Sundry Print Report

Well Name: DR PI FEDERAL UNIT 17_8 DA

Sundry ID: 2754884

Type of Action: APD Change

WELL LOCATION AND ACREAGE DEDICATION PLAT

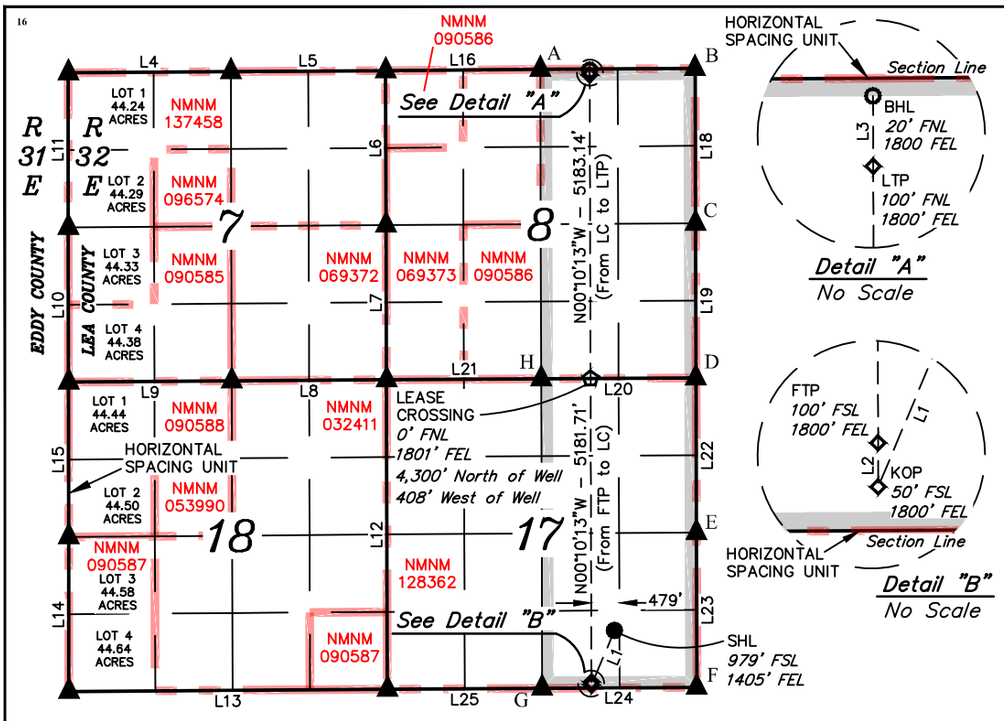
SCALE
DRAWN BY: D.J.S. 11-01-22
REV: 1 03-23-23 Z.L. (SHL, BHL CHANGE & ADD LEASE INFO.)
